PROJECT: FPMC, LIDCOMBE									
DRAWING TITLE: CAR PARK REVIEW PARKING & CIRCULATION									
CLIENT: ROOT PROJECTS									
DRG. #: PTC-001									
PROJECT #: T2-1696									
SCALE: 1:500									
REV: 4

DRAWING TITLE:
CAR PARK REVIEW

HRV / REFUSE COLLECTION SWEEP PATH ANALYSIS

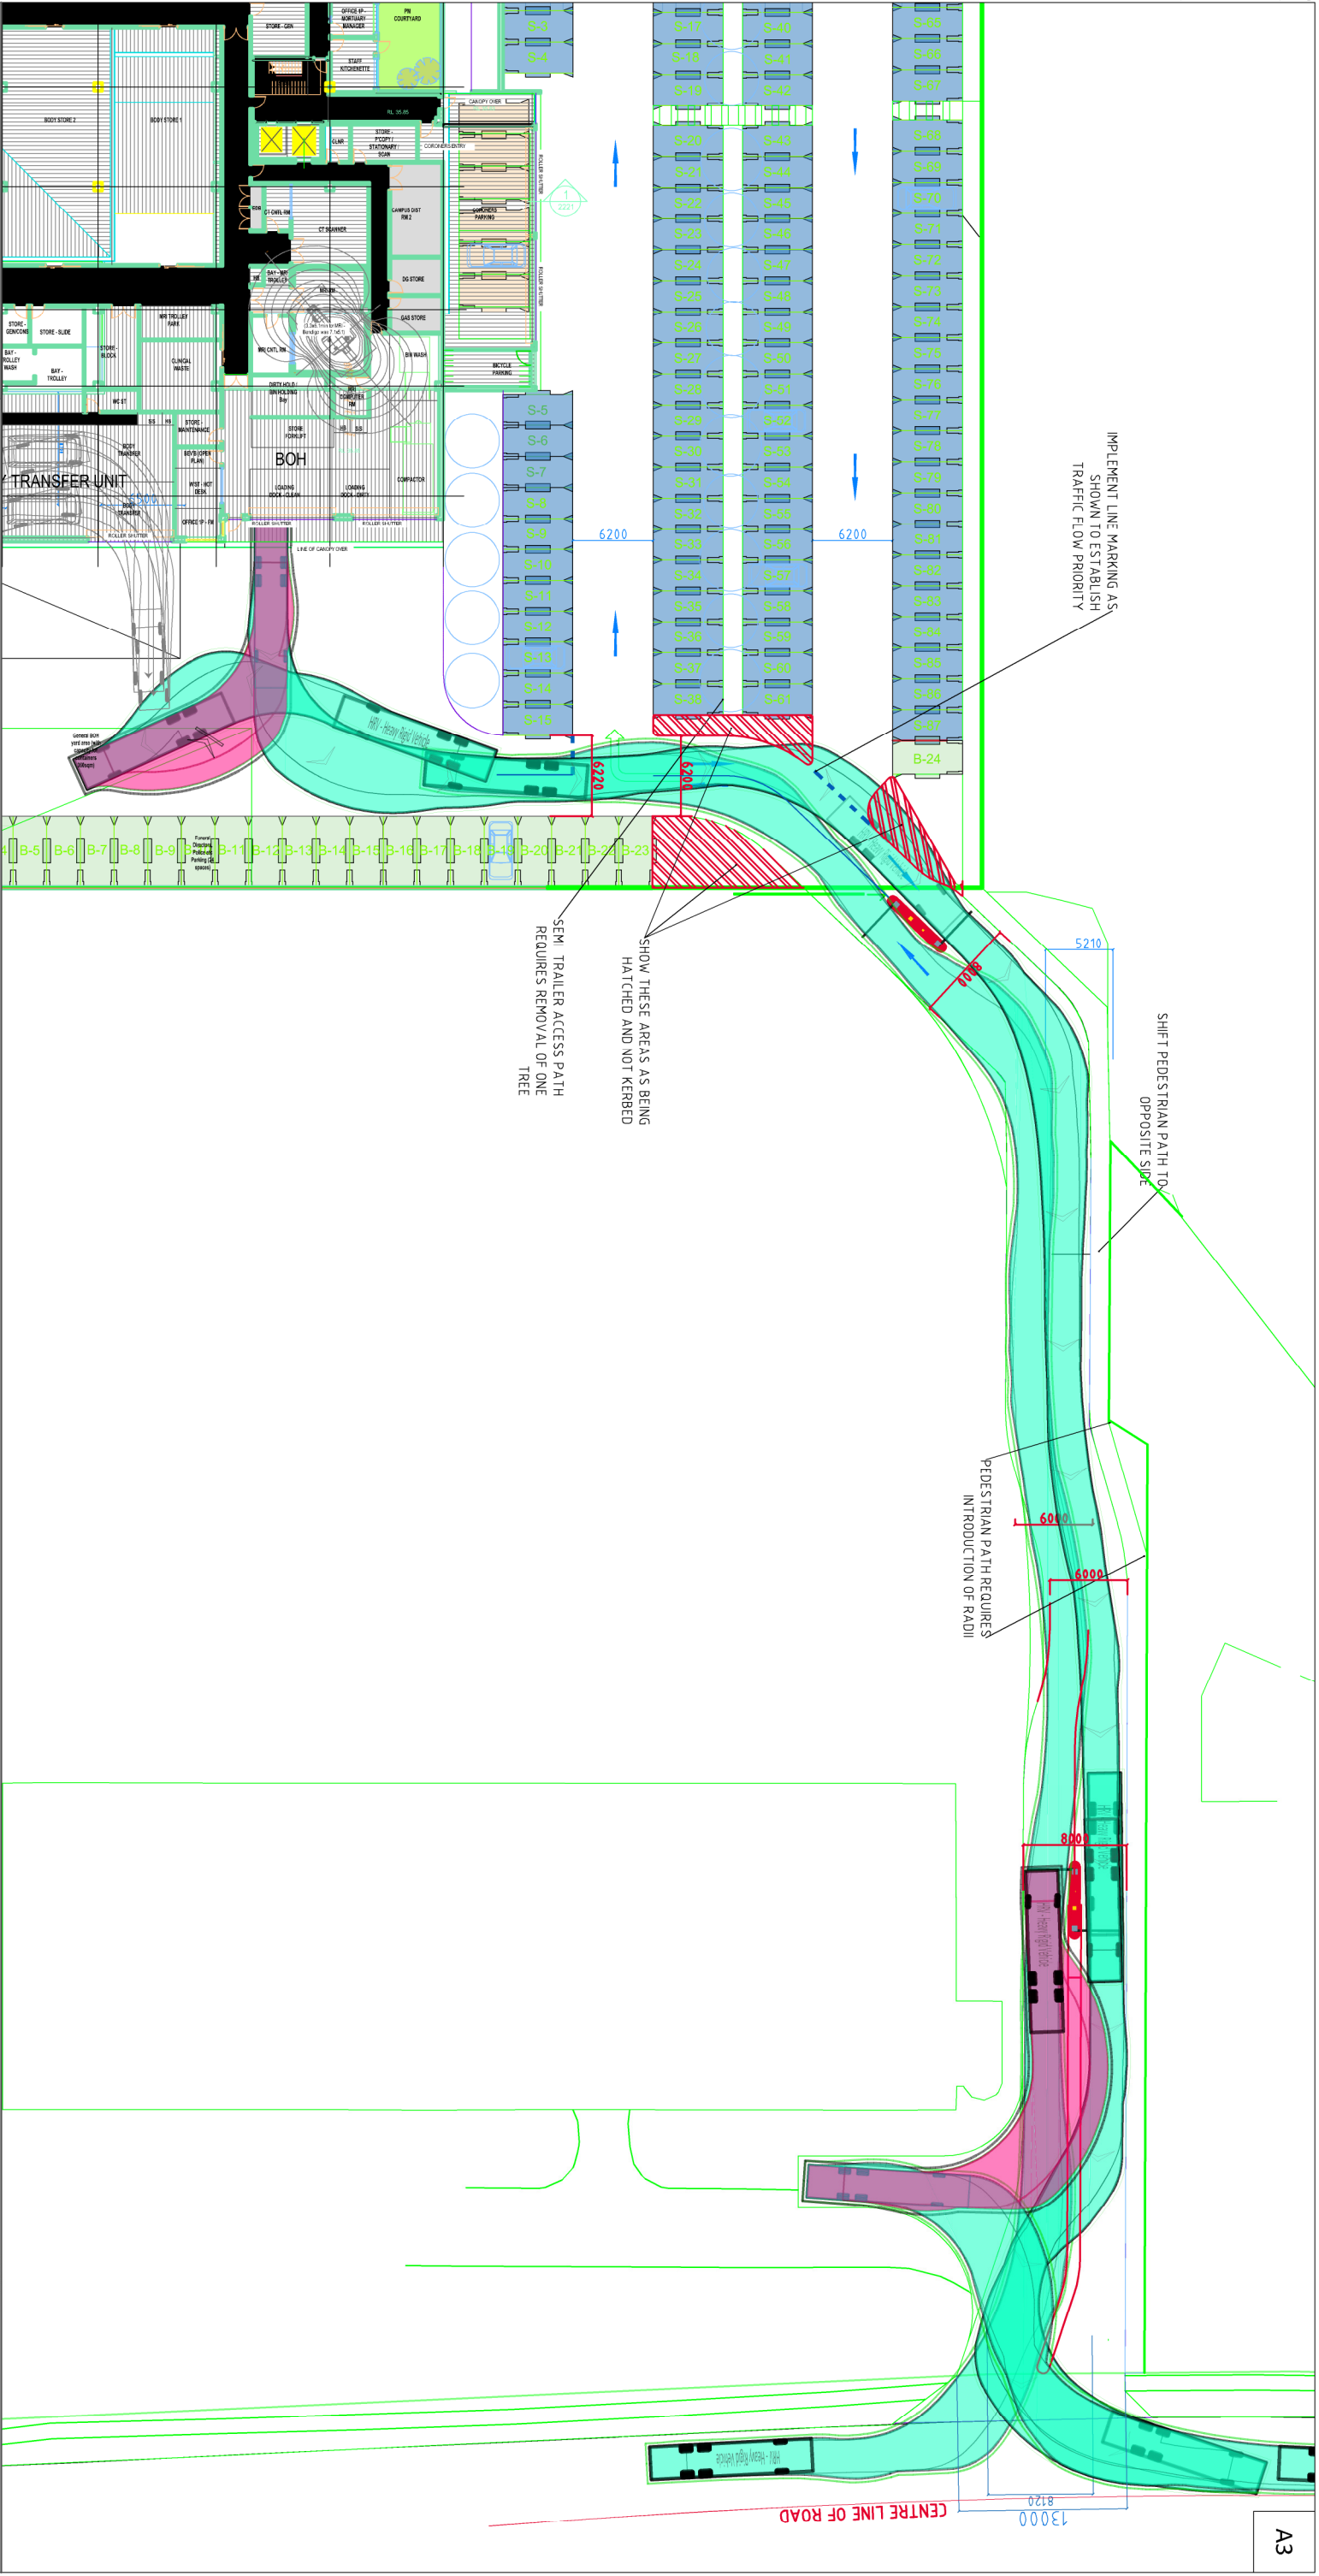
Height Clearance: **2.2m** (min) throughout all areas of car park accessible to vehicles and

bicycles.
2.5m above accessible and share
4.5m wherever access is required
refuse vehicle (and safety clearan
envelope)

Accessible Spaces: To be designed in accordance with AS2890.6, i.e. standard parking space with adjacent shared bay (2.4m x 5.4m), to be installed as per AS2890.6 requirements (bollard and markings).

Control Measures: Please note any recommended control measures, including line markings, signage, bollards, convex mirrors, signals etc.

Parking Spaces:	The parking envelopes shown, must be kept clear of all physical obstructions, including height clearance reductions.
Bicycle Parking:	Bicycle spaces are to allow for a 2.5m x 1.2m envelope (AS2890.1).

IMPLEMENT LINE MARKING AS SHOWN TO ESTABLISH TRAFFIC FLOW PRIORITY

SHOW THESE AREAS AS BEING
HATCHED AND NOT KERBED

SEMI TRAILER ACCESS PATH
REQUIRES REMOVAL OF ONE
TREE

DRG. #: PTC-002

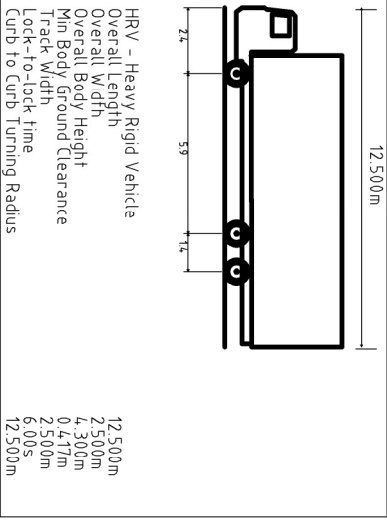
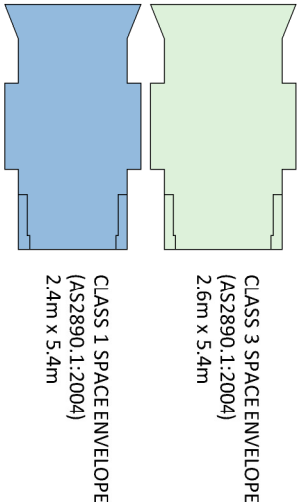
Height Clearance: 4.5m wherever access is required for a heavy vehicle (and safety clearance envelope)
